CITY OF  
**WEST ST. PAUL**  
**PLANNING COMMISSION MEETING**  
**MUNICIPAL CENTER COUNCIL CHAMBERS**  
**1616 HUMBOLDT AVENUE, WEST ST. PAUL, MN 55118**  
**TUESDAY, JULY 21, 2020**  
**6:30 P.M.**

4.A. PC Case #20-06 - Preliminary/Final Plat Review For 895 Robert Street - Dakota County  
CDA

4.B. PC Case #20-07 - Conditional Use Permit, Site Plan, Rezoning, Preliminary, And Final  
Plat Review For The Construction Of Two Apartment Buildings At 1201 Robert St. And  
100 Signal Hills Ave.

**CUP, Site Plan, Rezoning, and Plat for 1201 Robert St #50 and 100 Signal Hills Ave**

### Site Access – Livingston Avenue

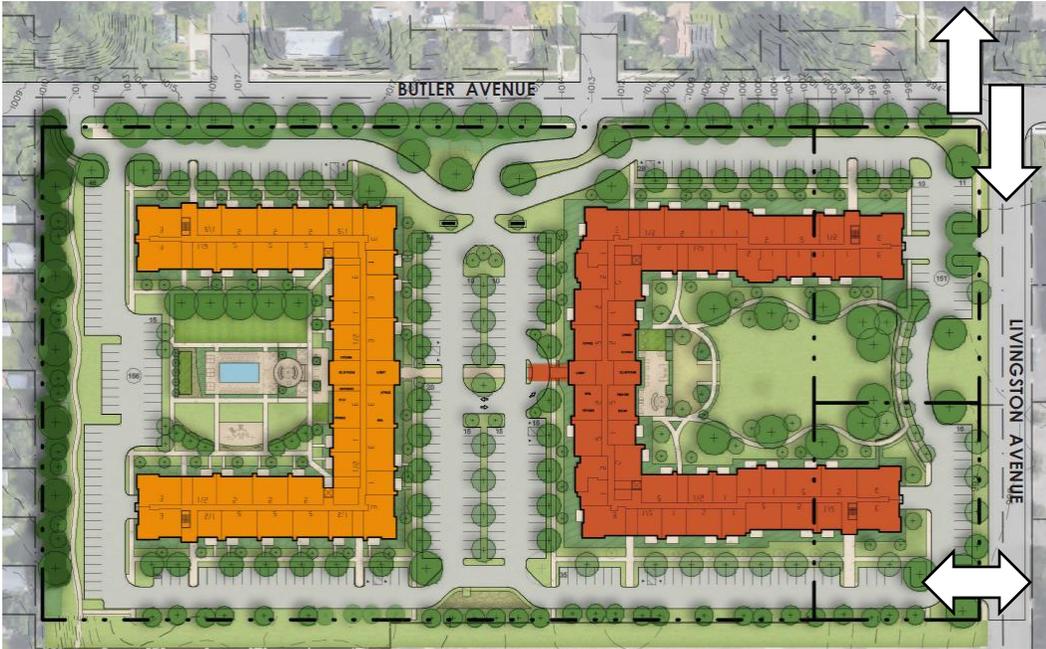
As a part of the site plan review, both Dakota County and the City would like to recommend that the applicant alter the site to allow for a re-alignment of the Livingston intersection to a proper “t” rather than an off-set intersection.

Figure 1 – Peak Hour Site Trips with Current Land Use Scenario

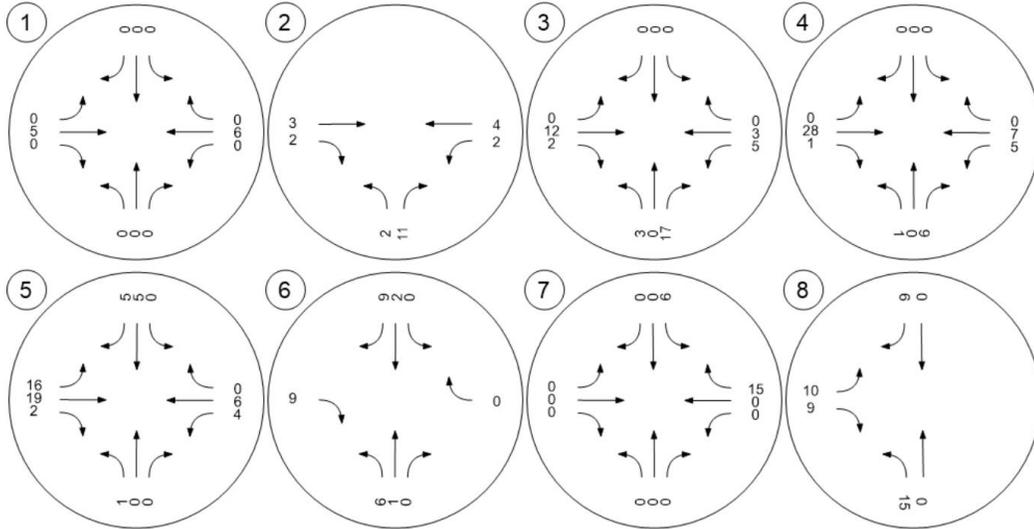
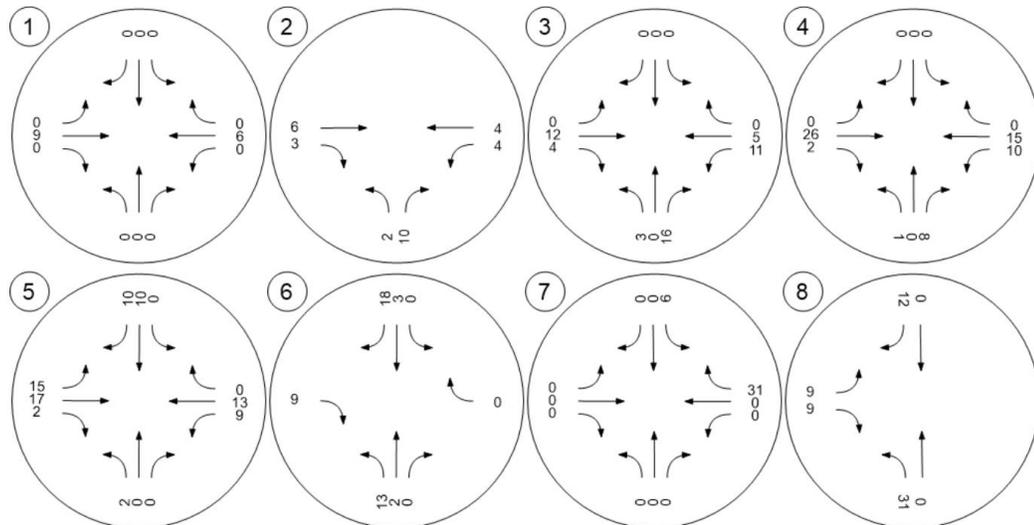
As seen in Figure 1, the highest hourly volume increase for any intersection movement due to the site traffic is 31 vehicles. This occurs at the westbound right turn at Livingston Avenue & Orme Avenue and the northbound left turn at Livingston Avenue & Site Access in the evening peak hour. This magnitude of new trips equates to an increase of roughly one vehicle every two minutes for that movement.

### Site Plan Review

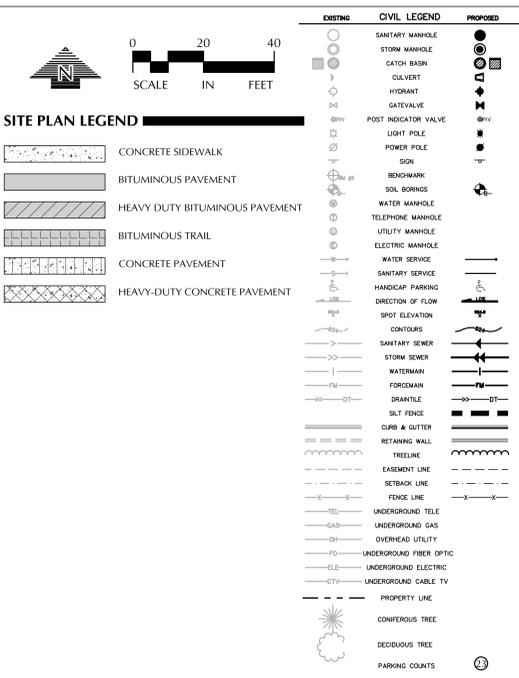
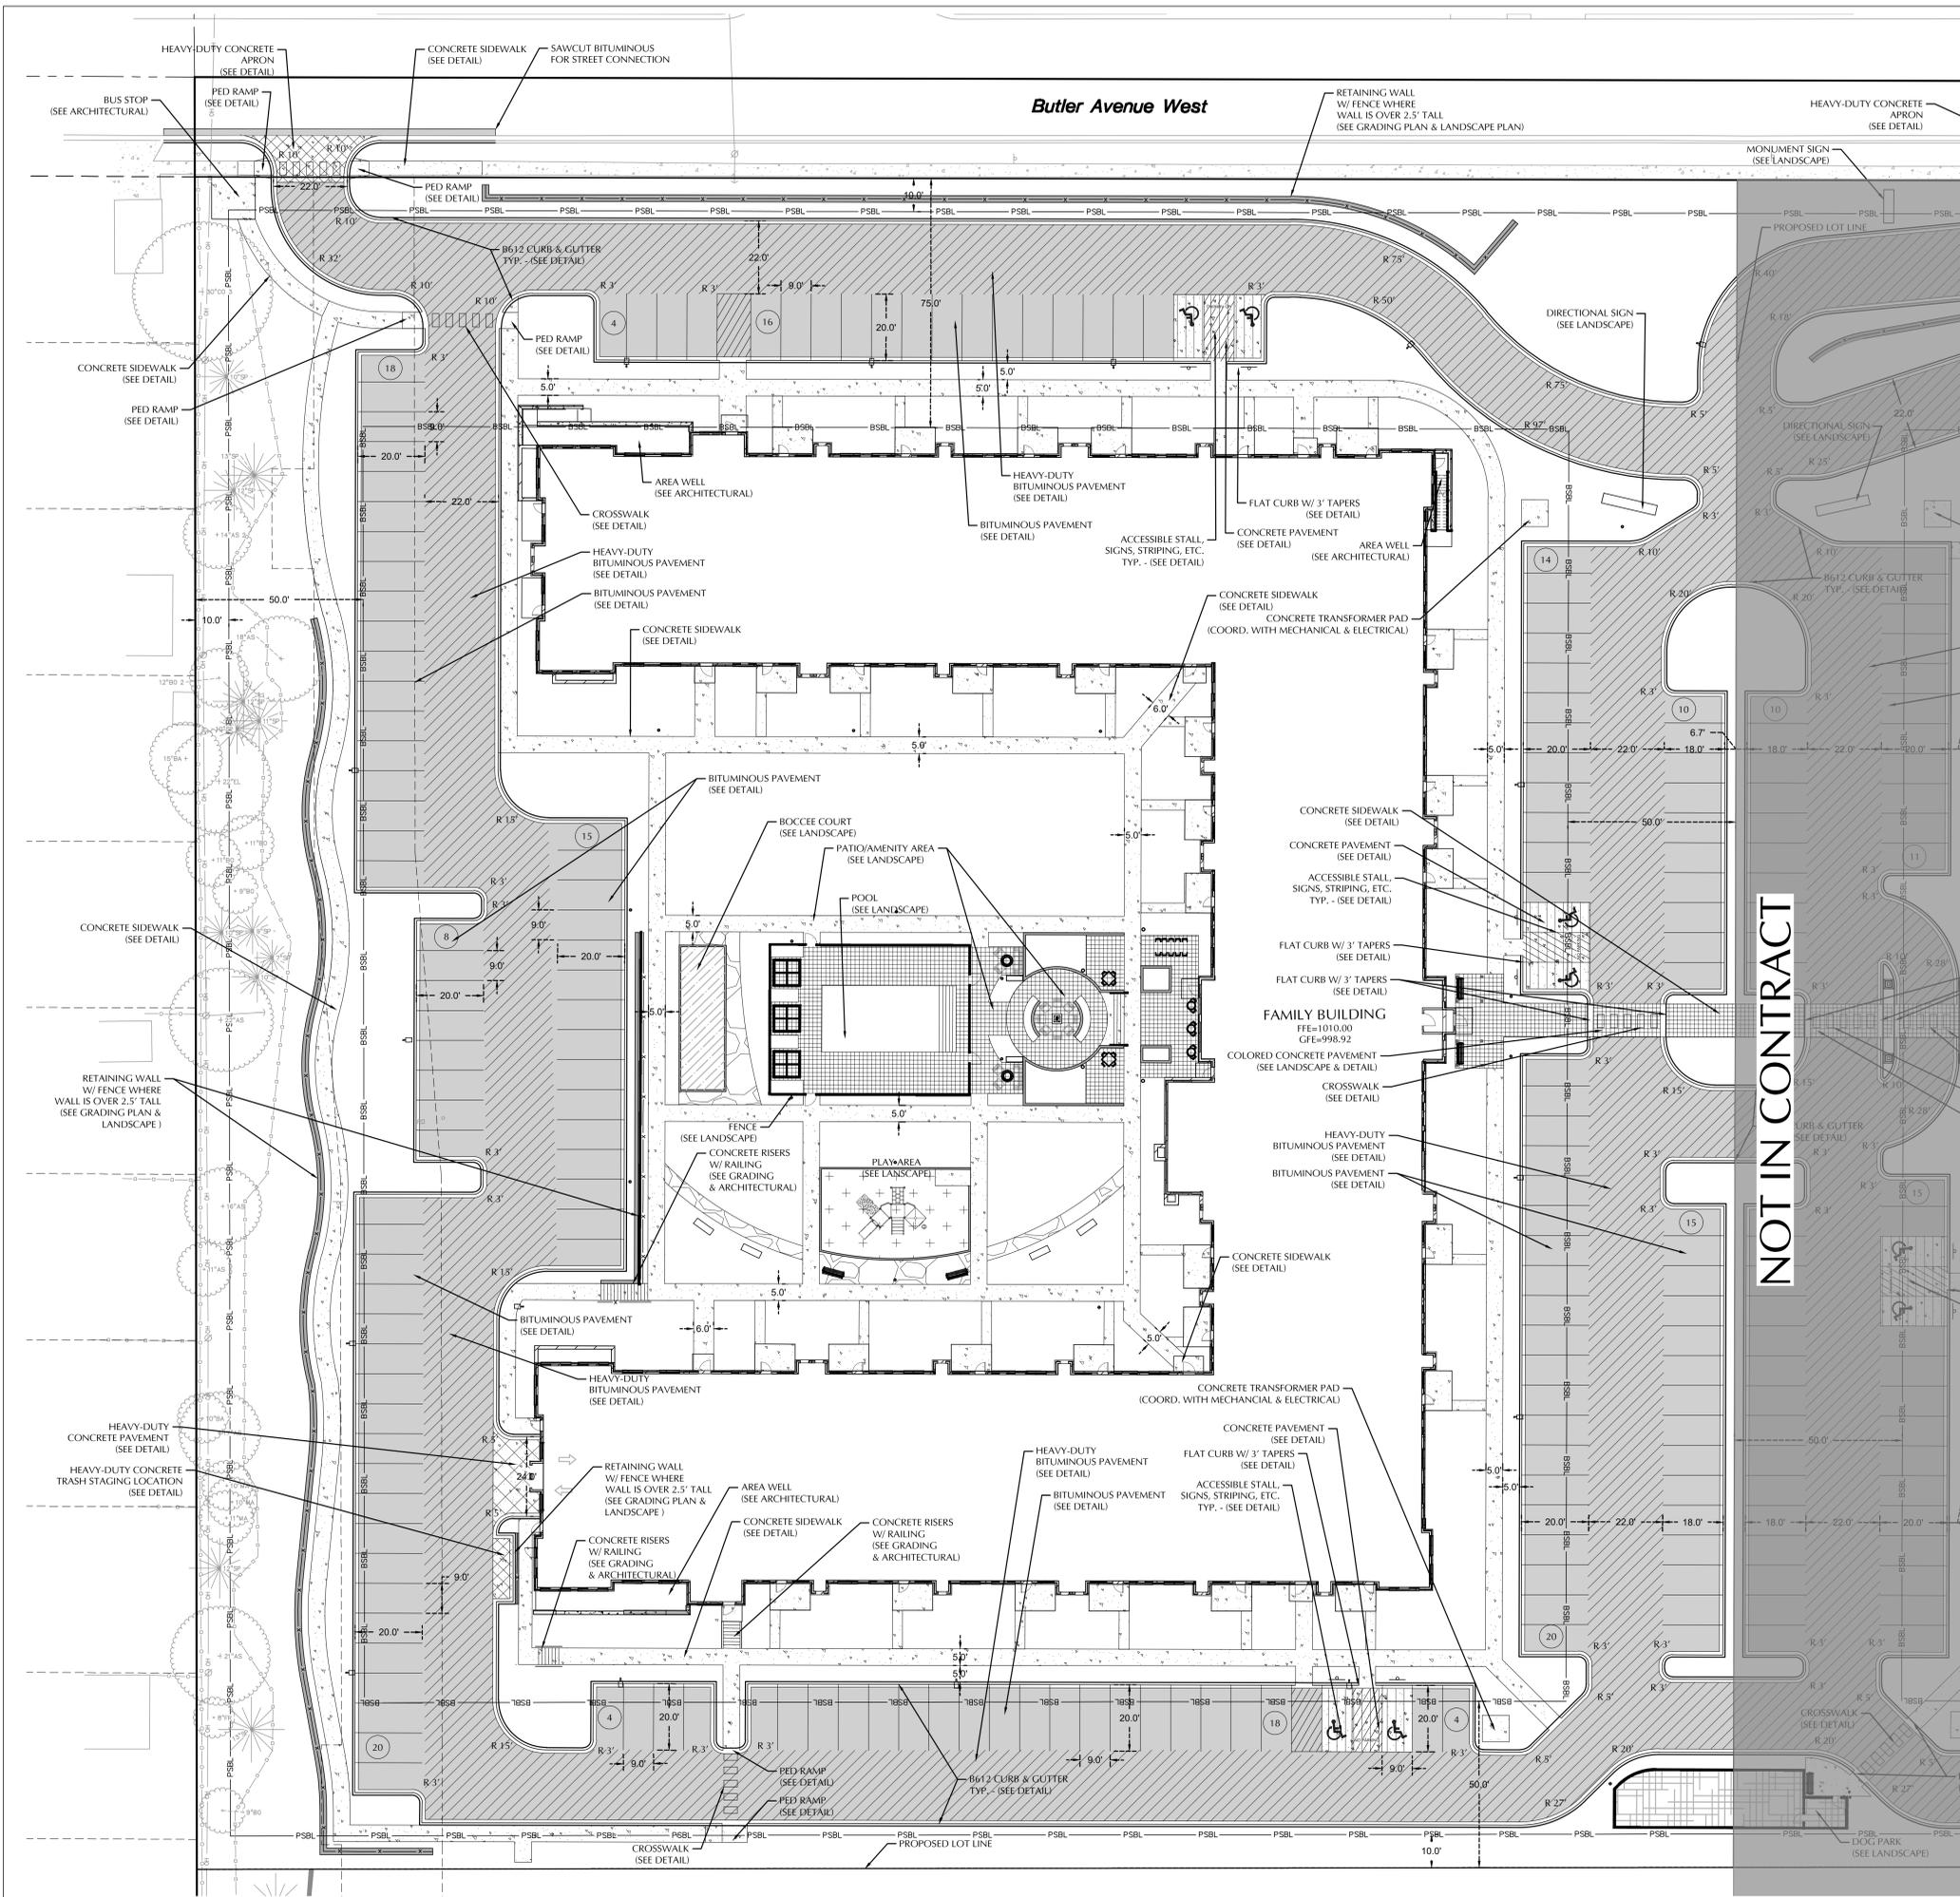
The proposed site plan was reviewed for traffic-related concerns. The following conditions are noted:

- Sidewalk Connections
  - Provide sidewalk extensions to the existing sidewalk along Butler Avenue.
  - Remove the internal crosswalks to the south of the development as they do not align with any receiving pedestrian infrastructure.

- Construct a sidewalk along the west side of Livingston Avenue with connections to Butler Avenue and Orme Avenue. This will provide safe pedestrian connections to the south.
